| Request | - | Special Use Permit for Day Care Center |
| Location | - | 111 W. Bancroft Street |

SPECIAL USE PERMIT
TOLEDO CITY PLAN COMMISSION
REF: SUP-12005-23
DATE: October 10, 2024
TIME: 2:00 P.M.

SITE PLAN REVIEW
FOR
ZONING CHANGE
FOR
SIMPLY AMAZING ACADEMY
111 WEST BANCROFT STREET
TOLEDO, OH 43606

SHEET NO.
A1.0

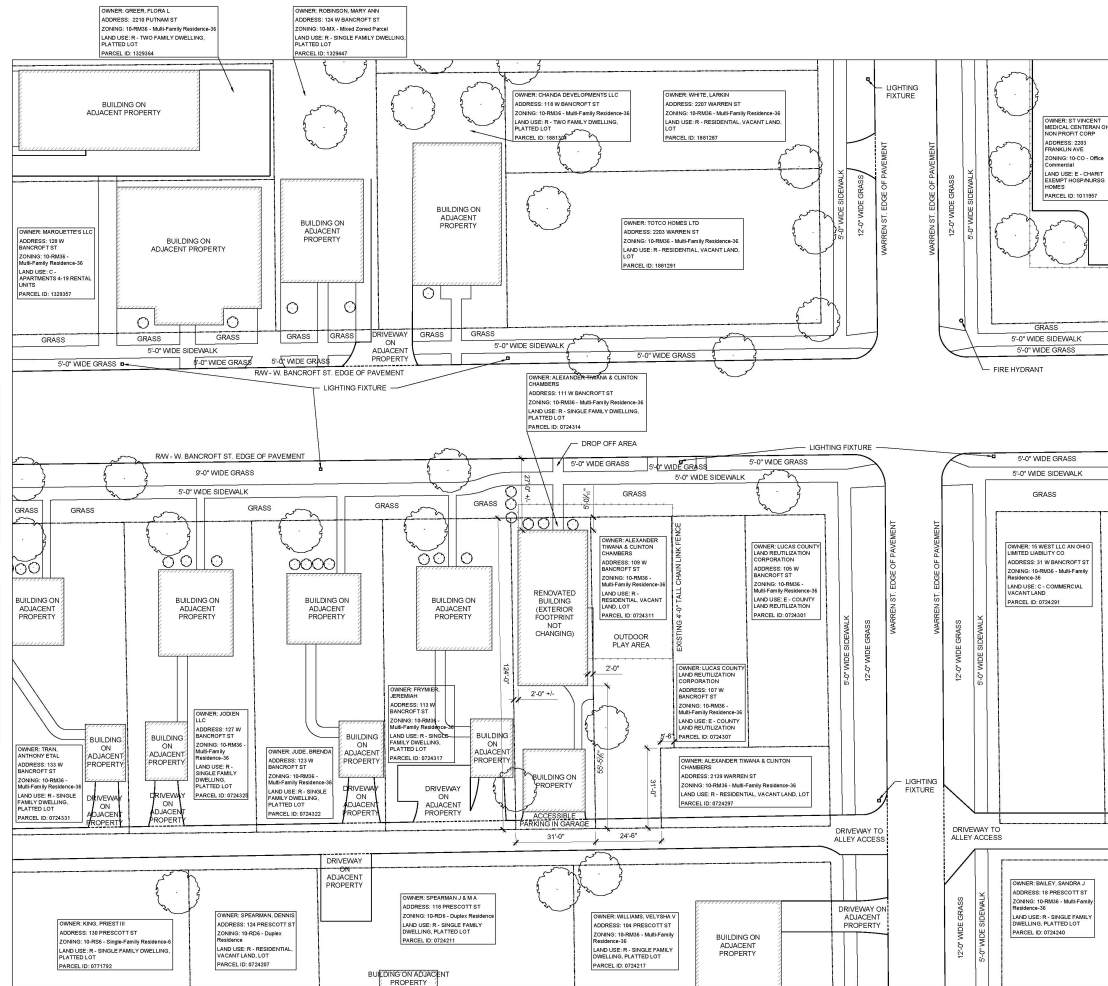
- Per TMC§1104.0703(F) a day care center must provide a paved off-street area for dropping off and picking up persons in their care. The Site Plan submitted proposes using Bancroft Street as a drop-off/pick-up area. As noted in Division of Transportation comments in Exhibit A, Transportation will not permit a drop-off/pick-up area on Bancroft in front of the subject property. Currently there is "No parking permitted between 8AM - 4PM" along the south side of Bancroft Street, where the subject property is located.

- Per the Off-Street Parking Schedule in TMC§1107.0304 a day care center is required to provide 1 parking space per 6-person capacity or 1 per 400 square feet whichever is greater. In this case they are required to have 8 parking spaces based on the proposed 45 children the Day Care Center will serve. In addition, 1 bicycle space is required for every 10 parking spaces; or per TMC§1107.0901(B) a minimum of two bicycle parking slots shall be provided when the provision for bicycle parking slots is required. Finally, per TMC§1107.1701 one van accessible parking spot is required to be provided for 1-25 parking spaces. The only parking indicated on the site plan is accessible parking in an existing garage at the rear of the lot with access from an alley. The required 8 parking spaces, including one van accessible parking space, and two bicycle parking slots need to be provided with appropriate access from the parking spaces to the building entrance.

15. Chain link fence encroaching in the Right-of-Way along W Bancroft is not permitted. The chain link fence must be removed from the Right-of-Way and relocated on the property.

16. The accessible route from the accessible parking space must be clearly shown and must comply with ADA (Americans with Disabilities Act).
17. Transportation will not permit a drop off /pick up area designated on Bancroft in front of 111 W. Bancroft. (Currently there is "No Parking permitted between 8-4" in front of this address.)

20. Per TMC§1104.0703(E) a day care center is required to provide 60 square feet of useable outdoor space for each person in their care using the outdoor space at any one time. **Not acceptable as depicted. The fence shall be reconfigured on the site, removing it from the right-of-way, and complying with this requirement as well as height, setback, landscaping and screening requirements of the Zoning Code.**

21. Per TMC§1104.0703(F) a day care center must provide a paved off-street area for dropping off and picking up persons in their care. The Site Plan submitted proposes using Bancroft Street as a drop-off/pick-up area. This is not permitted per the Division of Transportation. **Not acceptable as depicted. A paved off-street area for dropping off and picking up persons in care at the facility must be provided and approved by the Division of Transportation.**

22. Per the Off-Street Parking Schedule in TMC§1107.0304 a day care center is required to provide 1 parking space per 6-person capacity or 1 per 400 square feet whichever is greater. A total of 8 parking spaces are required based on the proposed 45 children the day care center will serve. No off-street parking is provided outside of existing garage. **Not acceptable as depicted. An off-street parking area shall be required with a minimum of 8 parking spaces.**

24. Per TMC§1107.1701 one van accessible parking spot is required to be provided for 1-25 parking spaces. The only parking indicated on the site plan is accessible parking in an existing garage at the rear of the lot with access from an alley. **Not acceptable as depicted. One van accessible parking space shall be provided.**

- b. Per TMC§1104.0703(E) a Type B landscape buffer is required around the outdoor space in accordance with TMC§1108.0203(F). This section requires a landscape buffer of 10 feet in width with four canopy trees and 15 shrubs installed every 100 linear feet. A 4-foot-high chain link fence is proposed. **Not acceptable as depicted. Since the proposed fence is not a solid fence or opaque in nature, 15 shrubs and four canopy trees for every 100 linear feet along the exterior of the reconfigured outdoor space is required.**
